LTR-NRC-21-33

Subject: NSAL-20-1 Revision 1, "Reactor Vessel Head Control Rod Drive Mechanism Penetration Thermal Sleeve Cross-Sectional Failure"

Subject: Reactor Vessel Head Control Rod Drive Mechanism Penetration Thermal Sleeve Cross-Sectional Failure	Number: NSAL-20-1 Revision 1
Basic Component: Thermal Sleeve in CRDM Reactor Head Penetration	Date: September 23, 2021
Substantial Safety Hazard or Failure to Comply Pursuant to 10 CFR 21.21(a)	Yes <input type="checkbox"/> No <input checked="" type="checkbox"/> N/A <input type="checkbox"/>
Transfer of Information Pursuant to 10 CFR 21.21(b)	Yes <input type="checkbox"/>
Advisory Information Pursuant to 10 CFR 21.21(d)(2)	Yes <input type="checkbox"/>

Figure 2 Thermal Sleeve Flange Failure Location

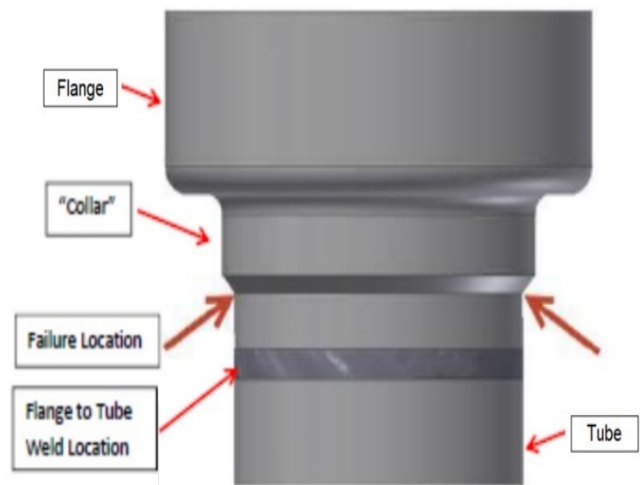
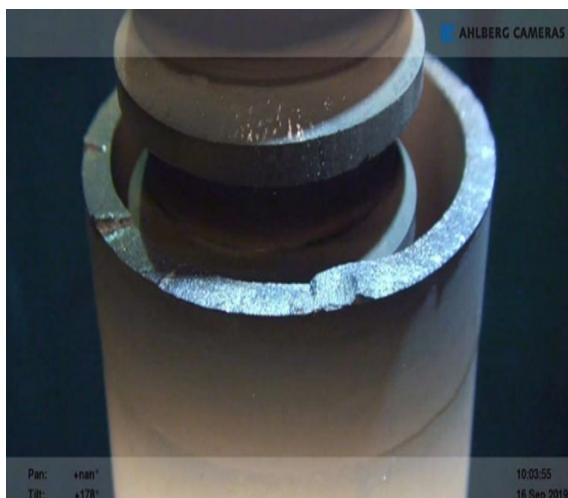
Operating experience (OE) in 2019 showed that Westinghouse nuclear steam supply system (NSSS) plants that operate in a T-cold configuration and have control rod drive mechanism (CRDM) penetration thermal sleeves with a collar below the flange (Figure 2), are susceptible to cracking and separation of the flange from the sleeve. This separated condition, when combined with the type of flange wear discussed in NSAL-18-1 [1], was conservatively assumed to be capable of impeding control rod movement and Rod Cluster Control Assembly (RCCA) insertability. In accordance with 10 CFR Part 21, Westinghouse identified this to be a potential defect and reported it to the U.S. NRC [2] on December 12, 2019.

In response to this OE, the affected utility performed a causal analysis with support from Westinghouse. Based on metallurgical examination of the separated sleeve, the analysis concluded that the most likely cause of failure was fatigue crack propagation. The analysis identified the transition between the collar and the tubular section on the outer diameter of the thermal sleeve to be a potential contributor, due to the stress concentration resulting from the tube wall thickness transition and potentially sharp transition radius in this location; however, this was not substantiated through the identification of a crack initiation site. These results were later corroborated through an industry-backed examination of the fractured part. This examination identified multiple initiation locations without a clear initiation mechanism.

- Operate with higher upper head bypass flow conditions, known as T-cold head plants.
- Operate with thermal sleeves containing a collar just below the flange (see Figure 2).

Revision 1 of this NSAL revises this position that CRDM penetration thermal sleeve flange separation due to cross-sectional fracture at the flange collar is a reportable defect. This revision summarizes the latest technical evaluation given in PWROG-21010-P [6], removes the inspection recommendations, and clarifies that CRDM thermal sleeve cross-sectional failures at the flange collar cannot create a substantial safety hazard.

Figure 4 Potential Flange Wedging Scenario

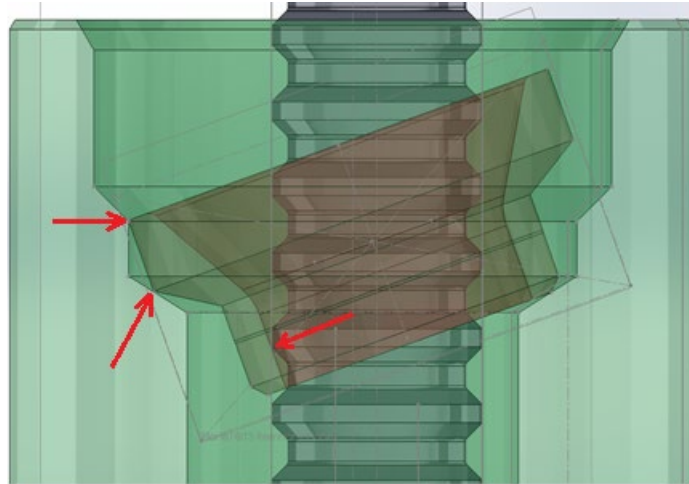
In certain conditions in which the CRDM housing is worn (as discussed in NSAL-18-1) and the thermal sleeve flange is separated from the sleeve, the flange remnant can move from its normal position and become misoriented at the top of the CRDM housing. Evaluations of this misorientation were conducted in support of Revision 0 of this NSAL and included a simplifying assumption that the drive rod could radially deflect far enough within the thermal sleeve and penetration housing assembly to permit the separated flange remnant to orient itself such that wedging could occur, as depicted in Figure 4.

The simplifying assumption and other geometric constraints were evaluated in PWROG-21010-P to determine the feasibility of this potential wedging scenario. It was determined that applicable forces and geometric constraints would not permit the drive rod to deflect far enough in the radial direction to allow wedging to occur. Moreover, the flange wear lowering criterion (i.e., the 0.80 inch lowering criterion) discussed in Revision 0 of this NSAL is no longer applicable as wedging cannot occur associated with a thermal sleeve that has fractured and separated at the collar, regardless of the amount of flange wear.

The evaluation documented in PWROG-21010-P concluded that CRDM thermal sleeve separation at the flange collar, as discussed herein, cannot impede control rod movement or RCCA insertability. Therefore, this failure scenario cannot create a substantial safety hazard.
